Process Sheet

Customer	: CU-DAR001 Dart Helicopters Services	Drawing Name	: STUB COVER
Job Number	: 38900		
Estimate Number	: 12415		
P.O. Number	:	Part Number	: D34941
This Issue	: 30/04/2008 S.O. No. :	Drawing Number	: D3494 REV B
Prsht Rev.	: NC	Project Number	: N/A
First Issue	: / /	Drawing Revision	: B
Previous Run	: 36863	Material	:
Written By	:	Due Date	: 10/05/2008
Checked & Approved By	: <u>JLD 08.4.30</u>	Qty:	10 Um: Each
Comment	: Est Rev:A New Issue 06-05-18 JLM est rev B ecn 888 06.12.13 EC

DESIGN <i>PH</i>	DRAWN BY <i>PH</i>	DART AEROSPACE LTD HAWKESBURY, ONTARIO, CANADA	
CHECKED <i>PH</i>	APPROVED <i>PH</i>	DRAWING NO. D3494	REV. B SHEET 1 OF 2
DATE 06.11.28		TITLE STUB COVER	SCALE 1:2
REV	DATE	DESCRIPTION	
A	06.01.16	NEW ISSUE	
B	06.11.28	REVISED FLAT PATTERN, BENDING DIMENSIONS, Ø0.208 X 0.268 SLOTS WERE Ø0.208 HOLES

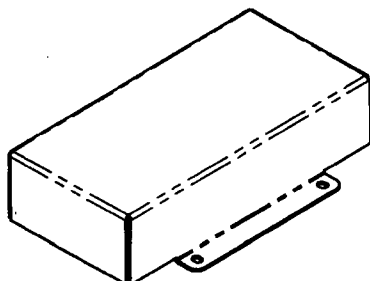
UNDER REVIEW

UPDATE BEND
DIMENSIONS 08.04.30

0.65 *B*
(TYP, REF)

0.72
PH
08.04.30

REF
PH
08.04.30

B 2.00 1.86 *B*

7.63 *B*

D3494-1F STUB COVER FLAT PATTERN

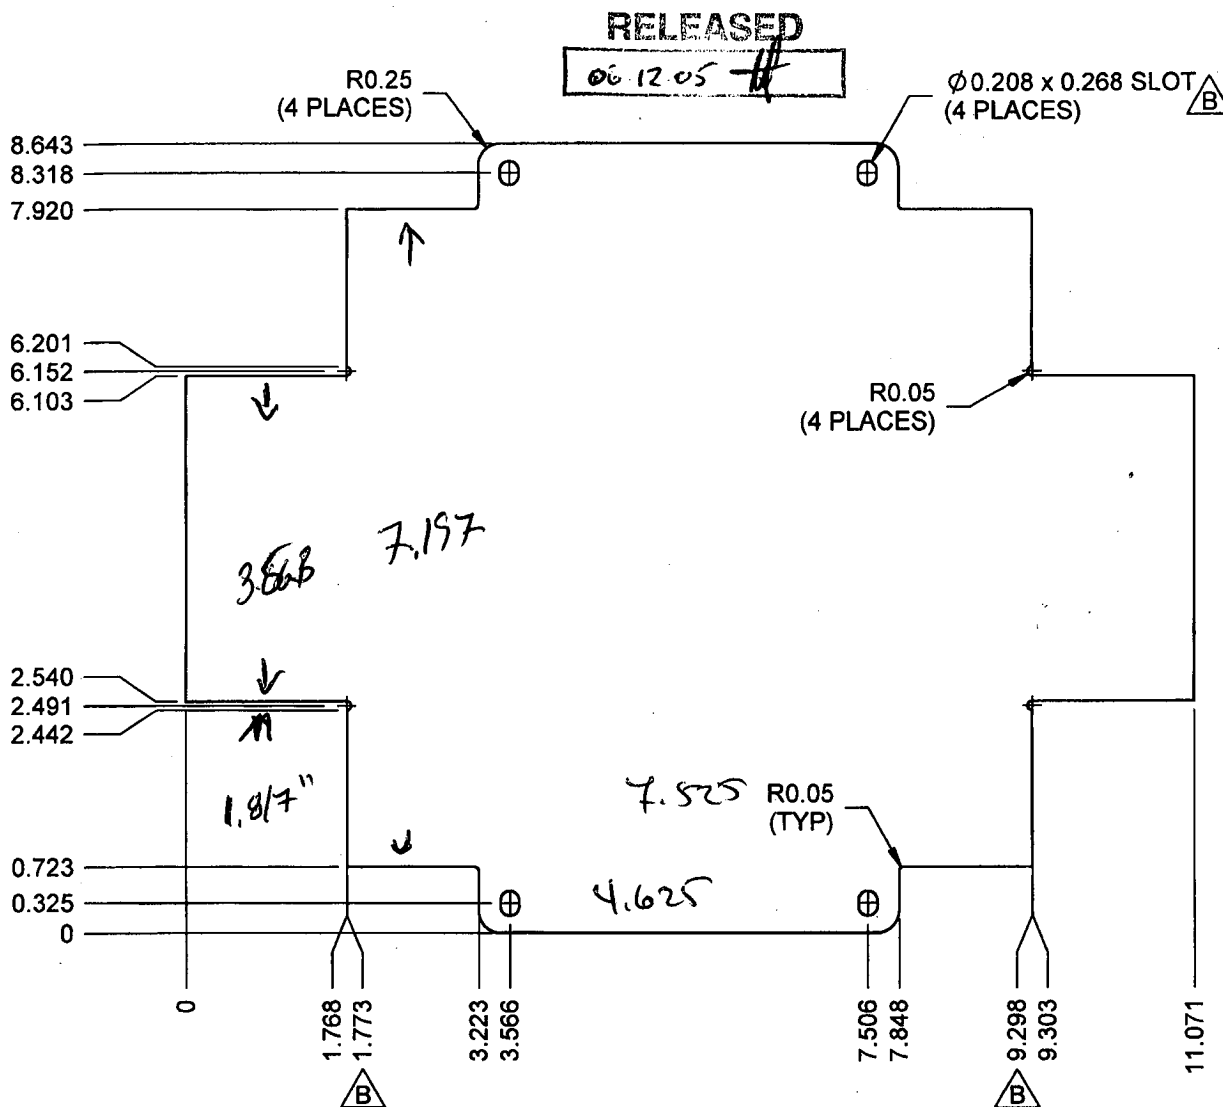
UNDER REVIEW

PH 03.04.30

UPDATE BEND
DIMENSIONS

TRIAL FIT
Pdt 08.05.08
